# Gloucester Lodge Design and Access Statement Addendum S.73 Amendment

**Date**  
July 2017

**Stage**  
Planning

This report is being submitted in support of applications for minor material amendments (S.73 of TCPA '90) and listed building consent.

## First floor

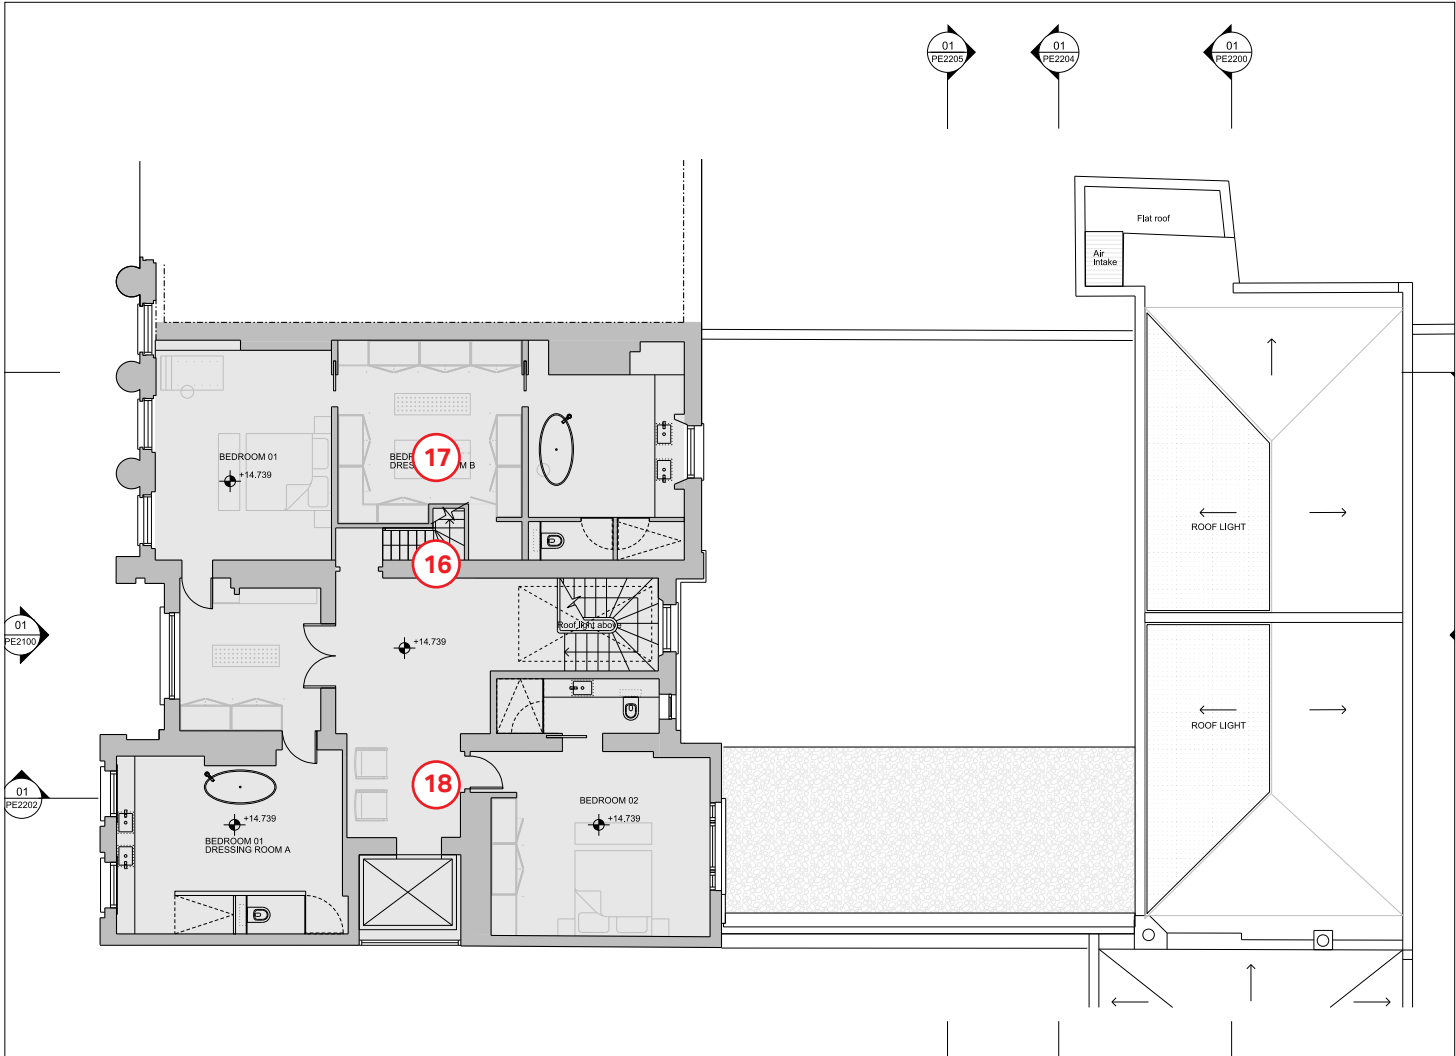
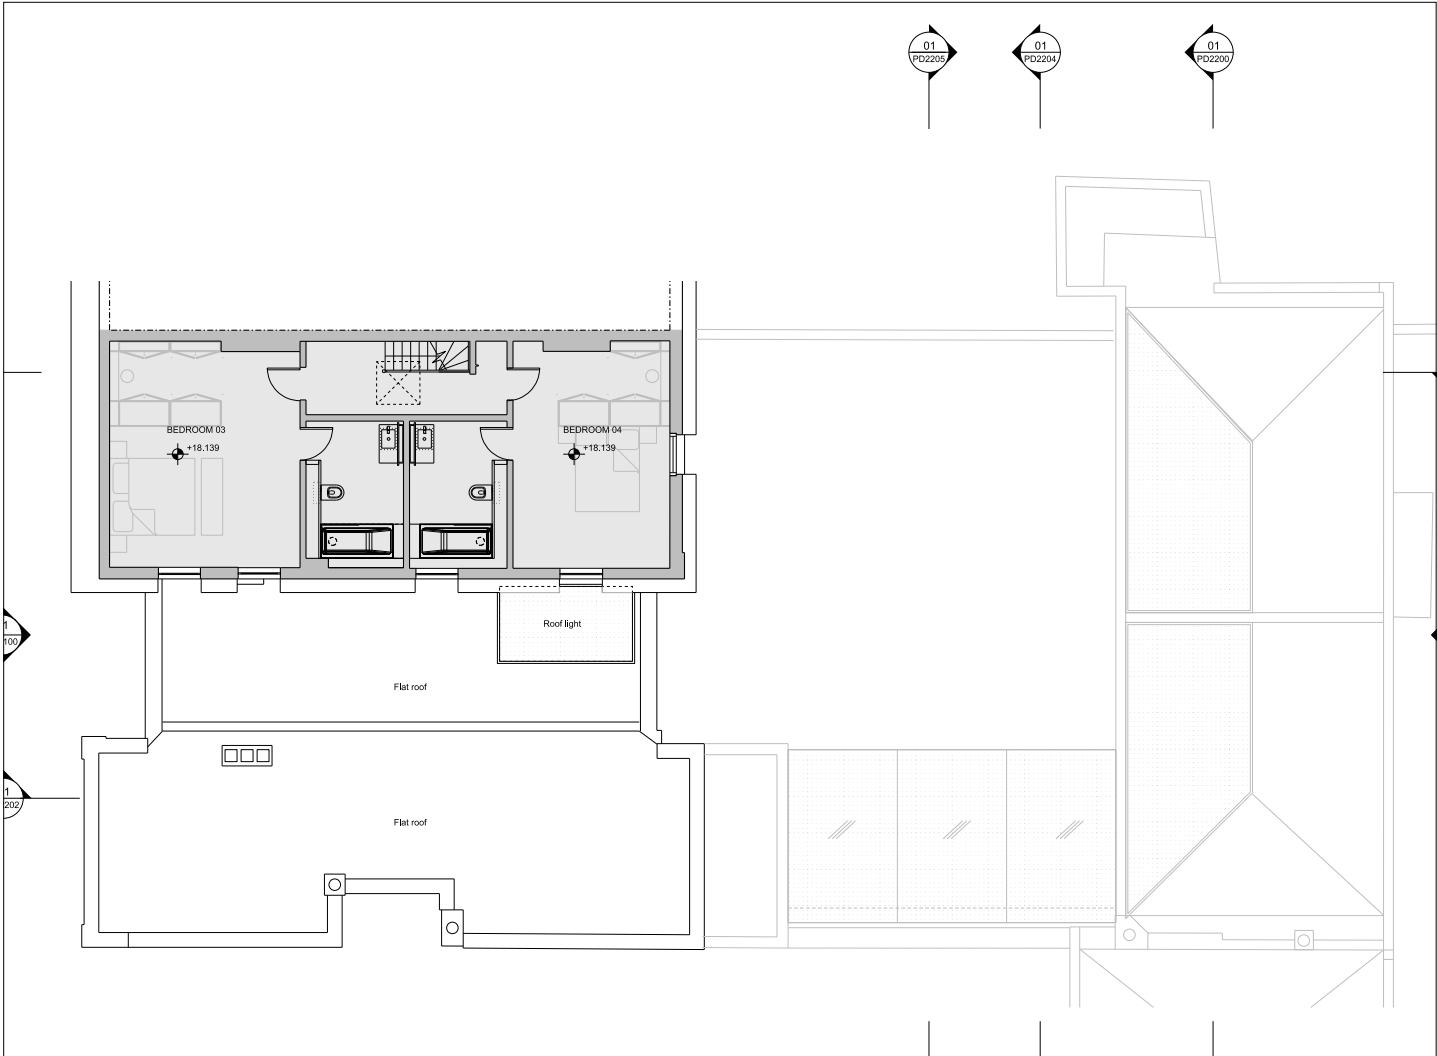
- 16 Staircase to second floor to be carefully rebuilt in nearby location. Hallway access adjusted to suit
- 17 Reconfigured Bedroom 01 layout
- 18 Reconfigured Bedroom 02 layout to address new location of lift

## Second floor

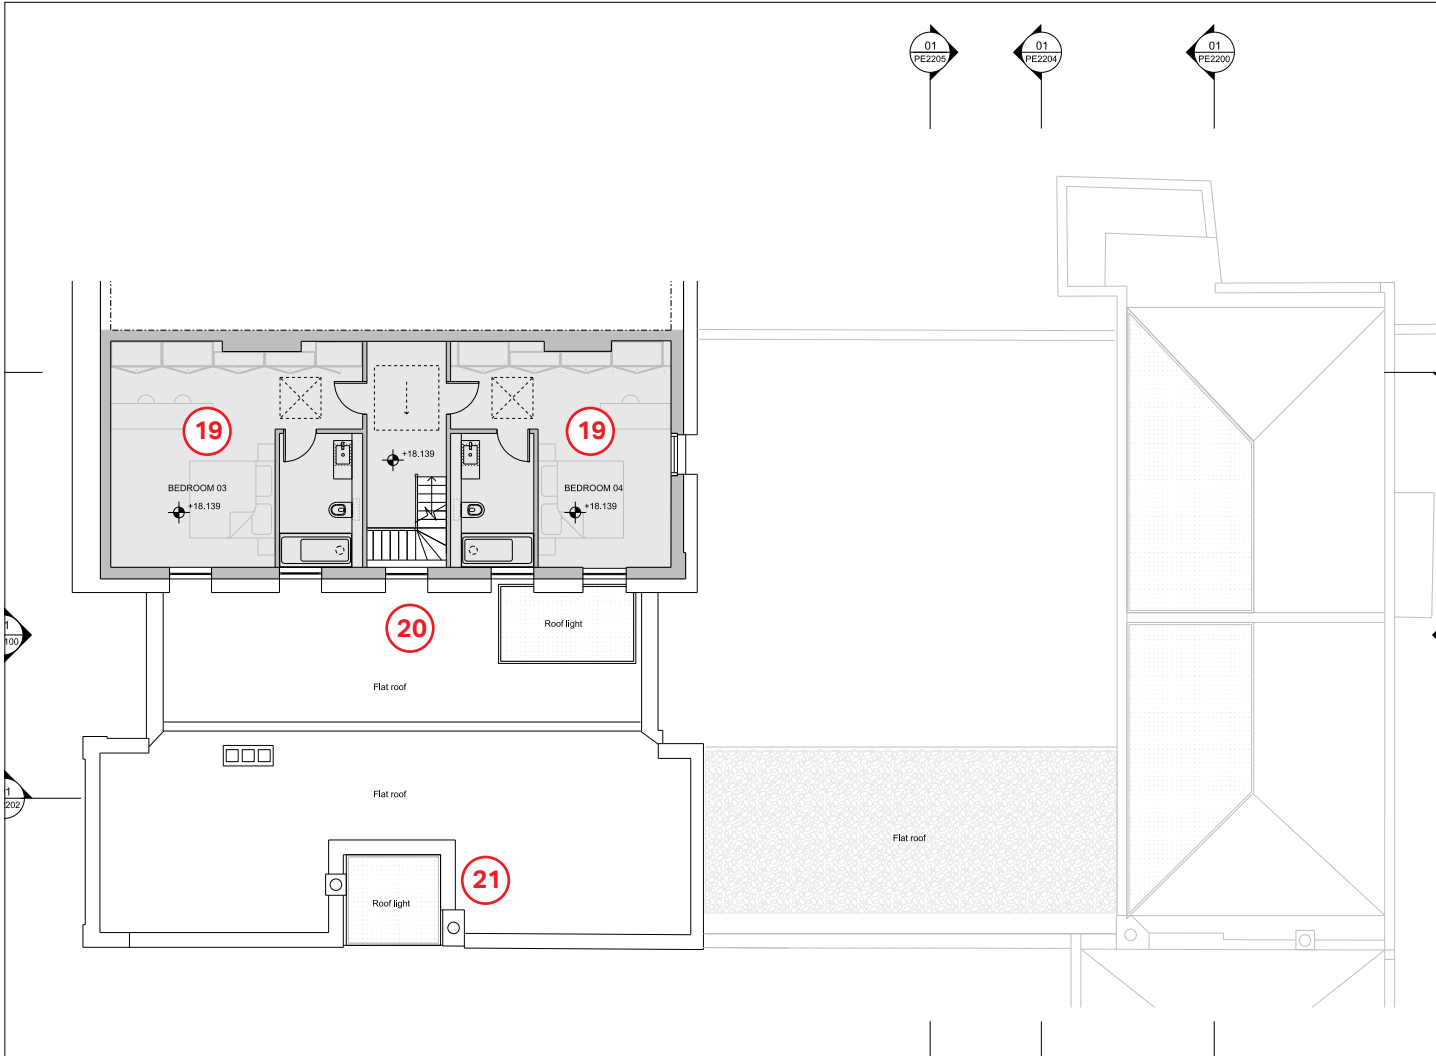
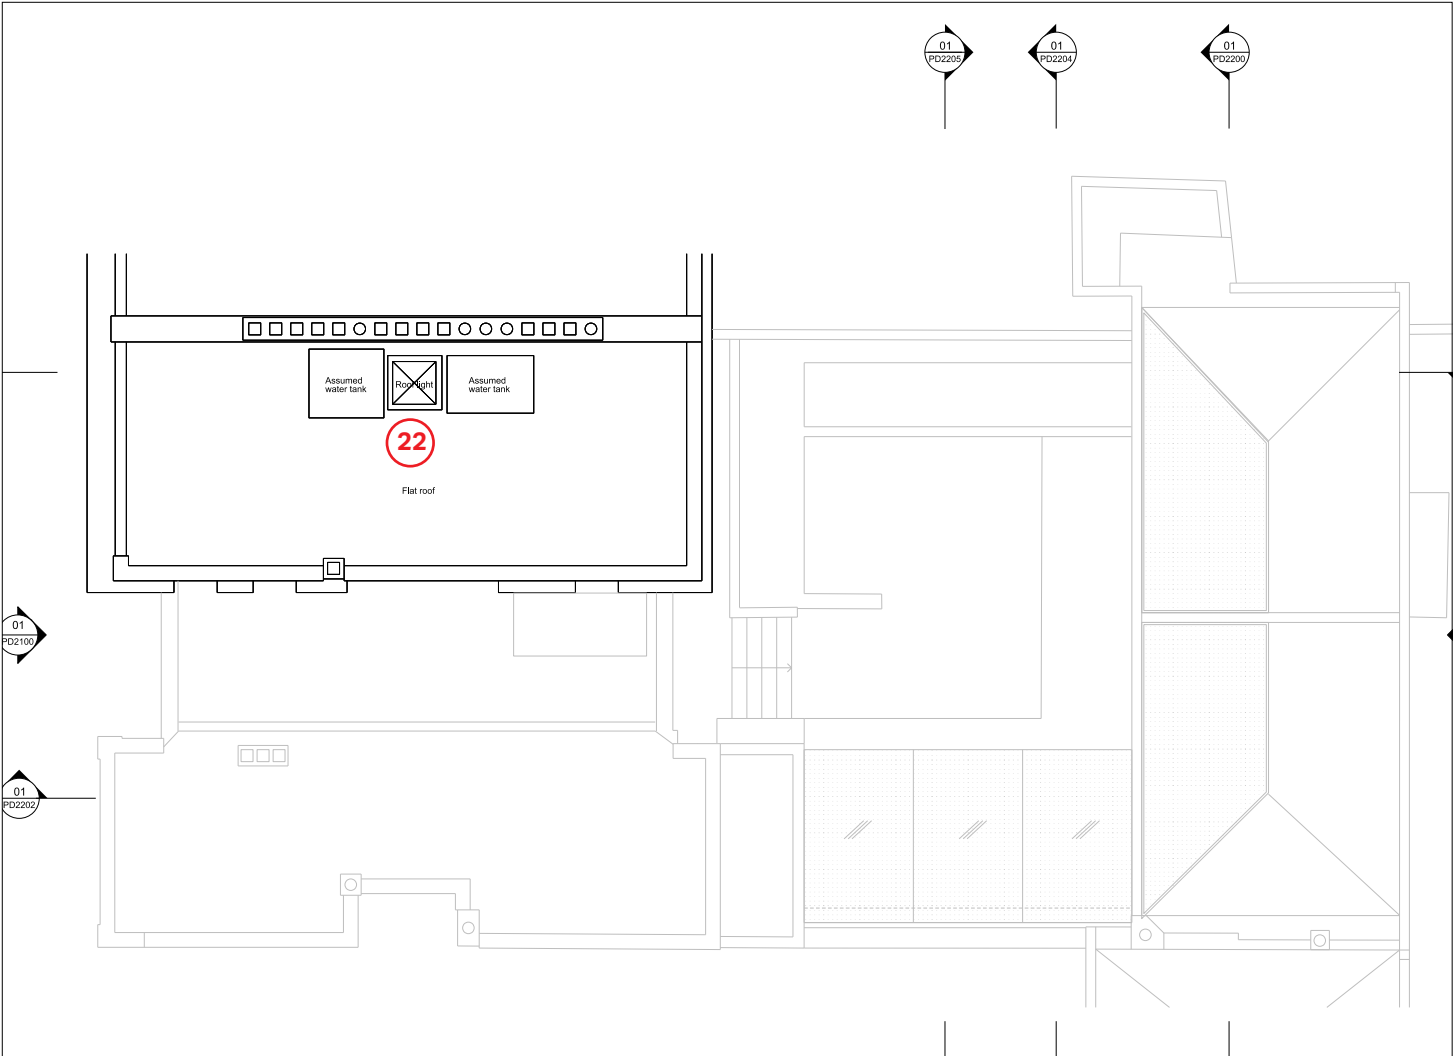
- 19 Layout of bedroom 03 and 04 amended to address the relocated stairs
- 20 Window openings adjusted with a new central window proposed for hallway
- 21 Flushed rooflight over new lift shaft with amendment to parapet

## Roof

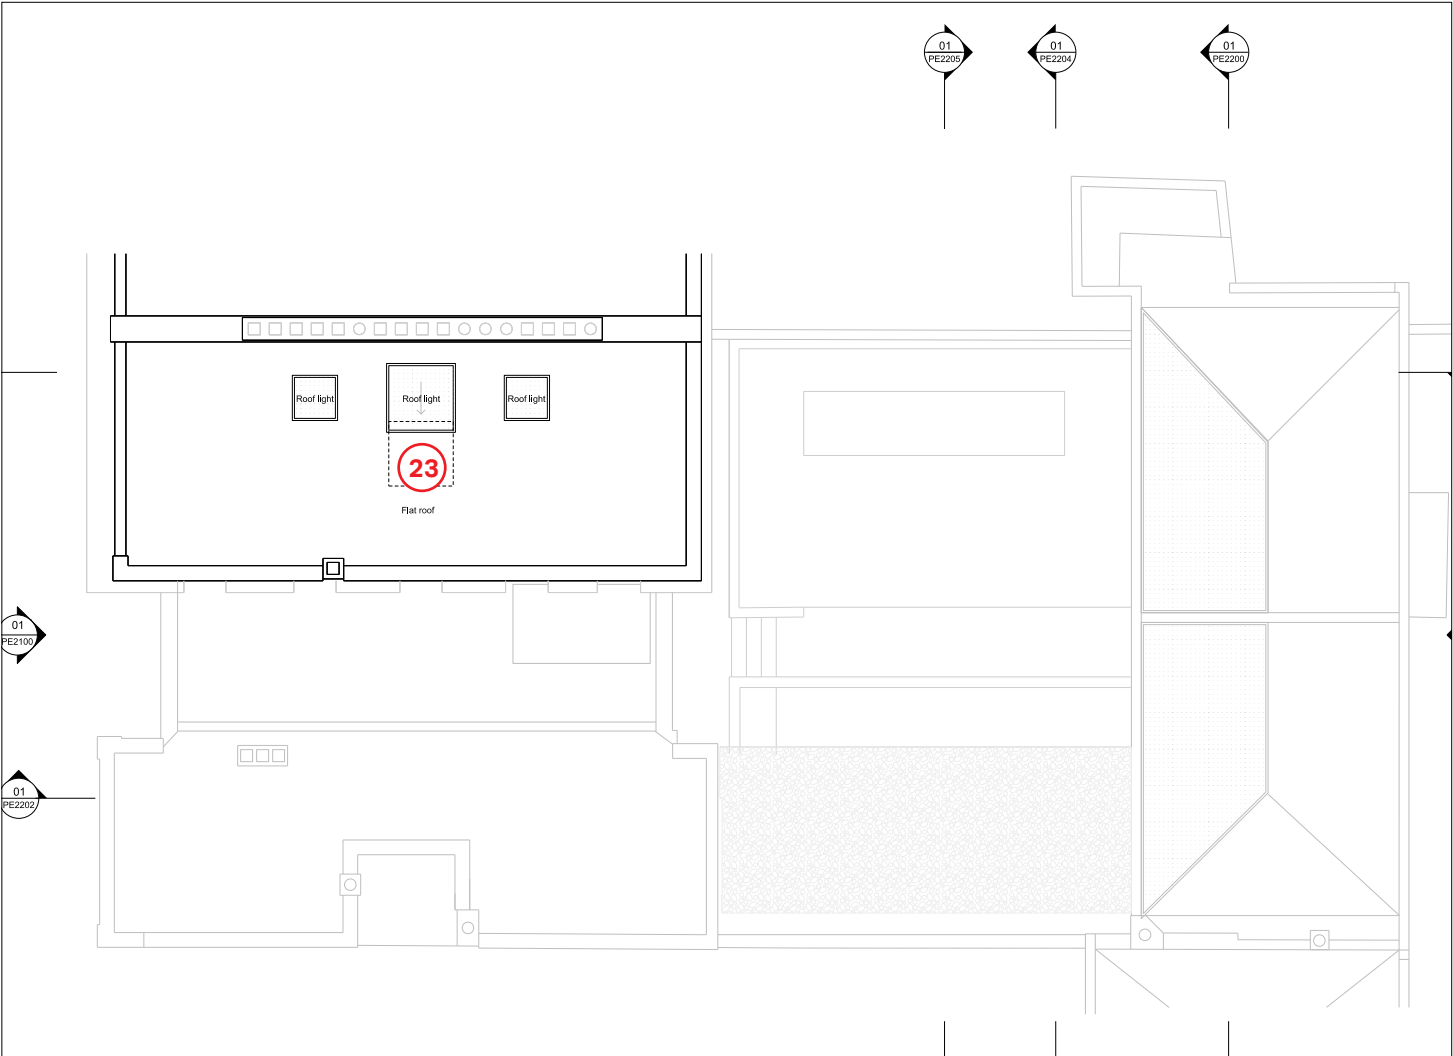
- 22 Existing rooflight and redundant water tanks removed
- 23 New rooflight proposed. Central rooflight to be openable to allow maintenance access
